STAFF REPORT 07-10-2019 MEETING PREPARED BY: A. PHILLIPS

**APPLICATION NUMBER: 19-6305**

**ADDRESS:** 1971 CHICAGO BOULEVARD **HISTORIC DISTRICT:** BOSTON EDISON

With the current proposal, the applicant is seeking the Commission's approval to erect a new elevated wood composite deck at the rear of the house per the attached drawings. Including the following scope items:

DECK & RAILING DETAIL SHEET NOT TO SCALE

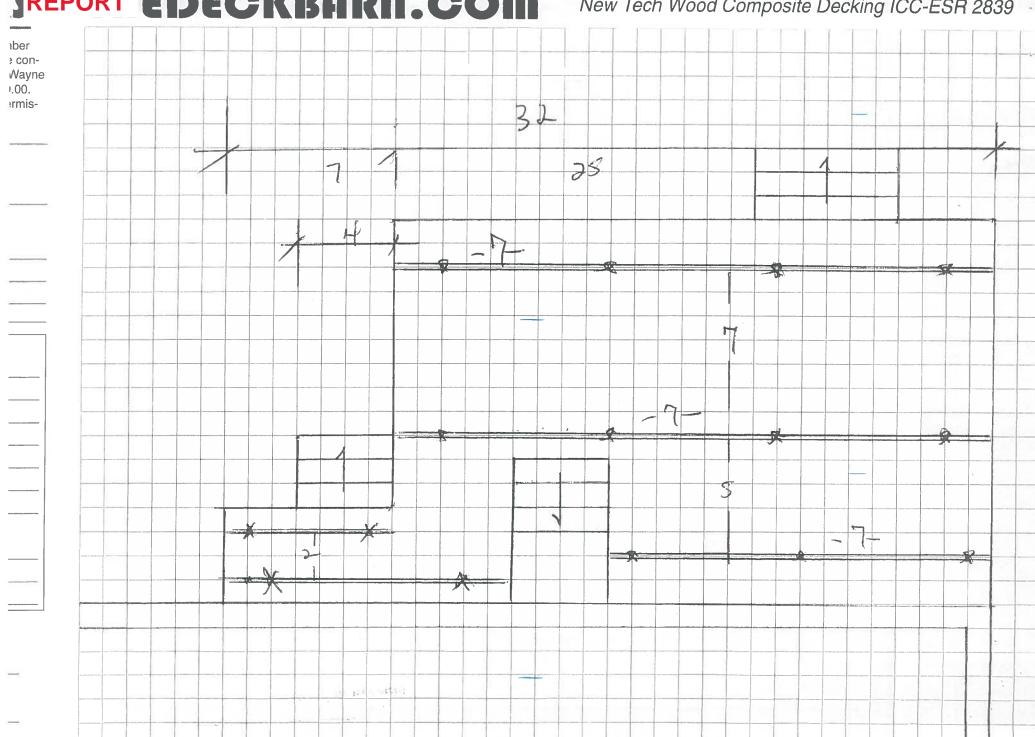
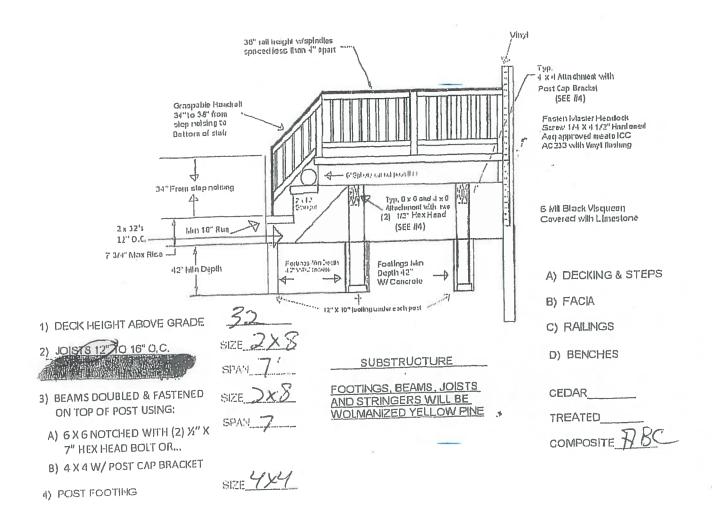
It is staff's opinion that the existing brick and concrete patio and steps proposed for demolition are not significant features of its historic character. It is currently unknown how or if the proposed wood deck will tie into the existing structure of the house. Staff has asked the applicant to provide more detail regarding this issue. Staff has also asked the applicant for more information regarding the "20 trapezoid vinyl post lights."

Given the recent discussion held amongst Commissioners at the June 26, 2019 HDC meeting regarding the appropriateness of the use of vinyl (windows, fences, siding, etc.), staff is concerned about the appropriateness of the "white PVC" of the handrail.

• The proposed railing should be of a more appropriate material than PVC
